File No: 2020/109789
Our Ref: R/2017/25/B
Your Ref: SSD-8924 & SSD-8925

Request for advice – The new Sydney Fish Markets – Concept and Stage 1 (SSD-8924) and Stage 2 (SSD-8925) – Response to Submissions (RtS)

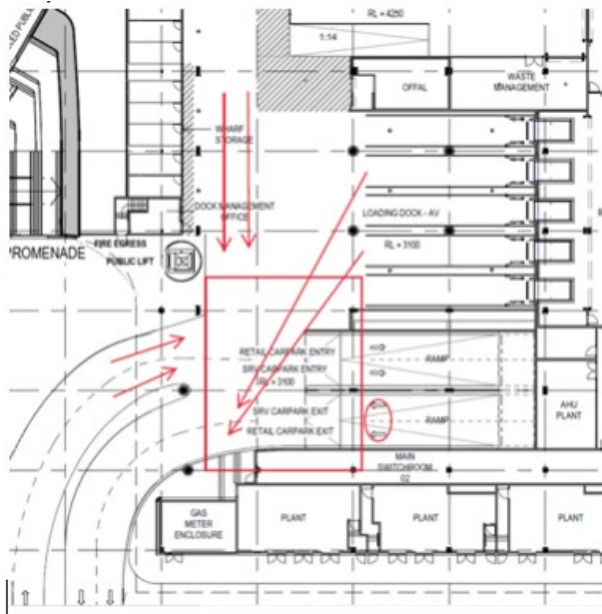
The submitted preliminary loading dock management plan has provided swept paths and includes some safety measures and procedures during heavy vehicle operations. Additional measure controlling the flow in the confluence (see figure below), however, have not been provided and should be addressed particularly where will the incoming/outgoing vehicle stopping line be to give way to the heavy vehicle manoeuvring. Any future approval must require this issue to be addressed in a consent condition.
